IMPORTANT SAFETY RECALL – 16V-435

Safety Notice

SN641

SUBJECT: Eaton Hydraulic Motor

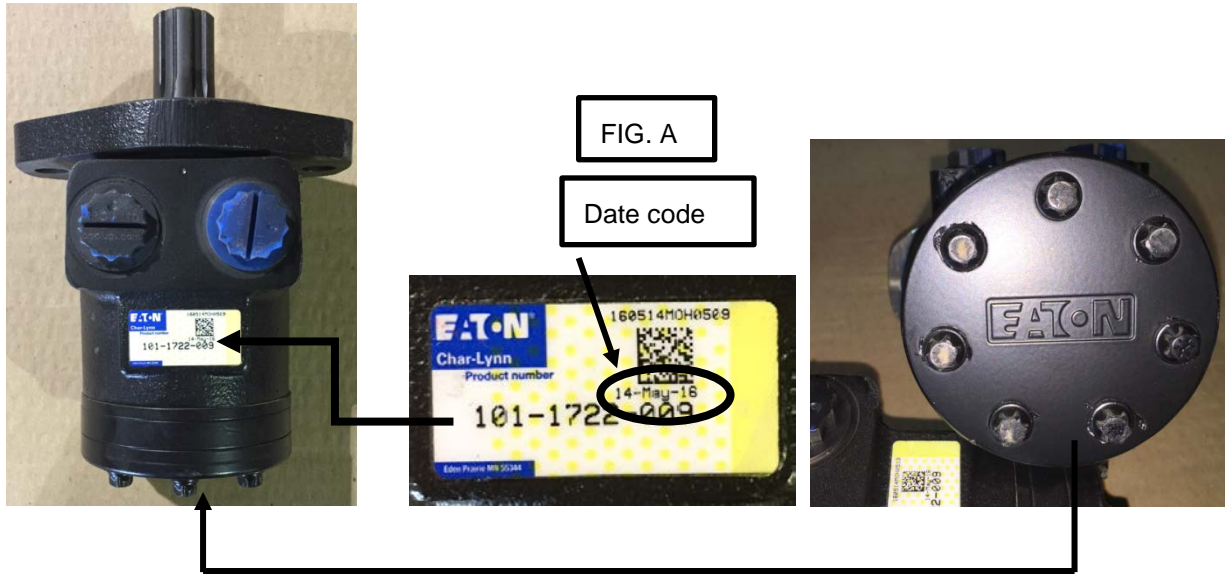
Locate the unit rotation hydraulic motor on the unit rotation gear box, the material handling jib winch hydraulic motor at the boom tip, or the front bumper winch hydraulic motor. Inspect the date code on the hydraulic motor tag. Reference FIG. A to identify the date code.

Any EATON hydraulic motor with a date code between 26-Dec-15 and 30-Mar-16 is subject to the recall and will need the hydraulic motor replaced.

Any EATON hydraulic motor with a date code before 26-Dec-15 or after 30-Mar-16 is not subject to this recall. Any hydraulic motor other than Eaton is not subject to this recall.
